**STATE OF DELAWARE  
EXECUTIVE DEPARTMENT  
OFFICE OF MANAGEMENT AND BUDGET  
STATE PLANNING COORDINATION**

RE: PLUS 2006-06-05; New Milton

Thank you for meeting with State agency planners on June 28, 2006 to discuss the proposed plans for project to be located north and south of Route 16 from Delaware Route 30 to Cedar Creek Road .

**New Milton 06-06 review (PLUS 2006-06-05)** The blue lines indicate the projects border, the Excellent Recharge area is shown as solid green.

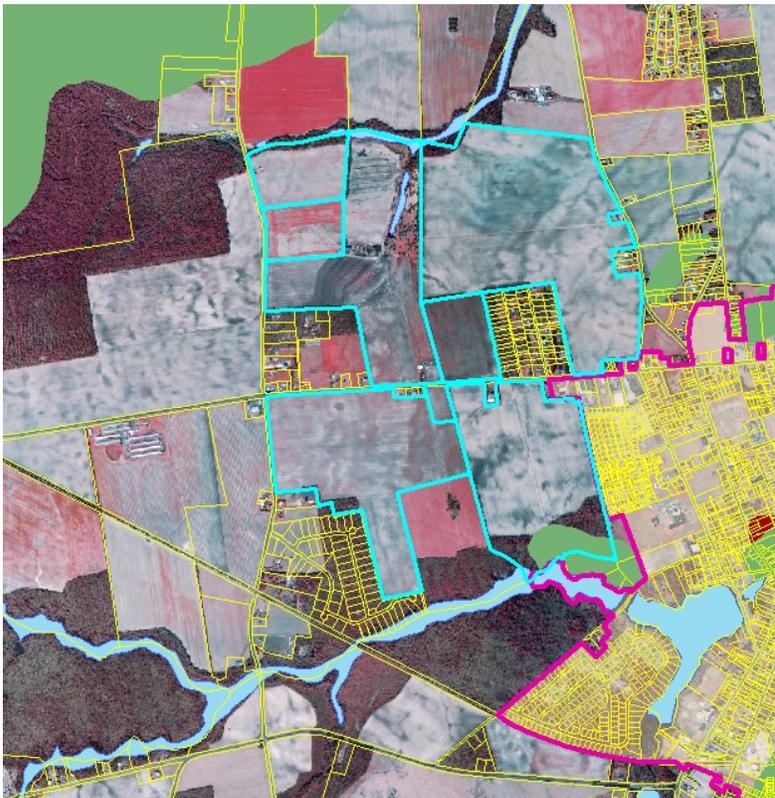
The DNREC Water Supply Section has determined that the southeastern edge of the proposed development falls within an area of excellent ground-water recharge (see following map and attached map).

The proposed development would change the total impervious cover from 0% to approximately 40% in proposed development area. The proposed development area does not impact the excellent ground water recharge area. The developer on the PLUS application provided these numbers.

DNREC Water Supply Section will comment further on the final placement of the public well(s), their associated wellhead protection area(s), the wastewater treatment plant, the spray irrigation facility, and the associated wastewater spray fields during the permitting process.
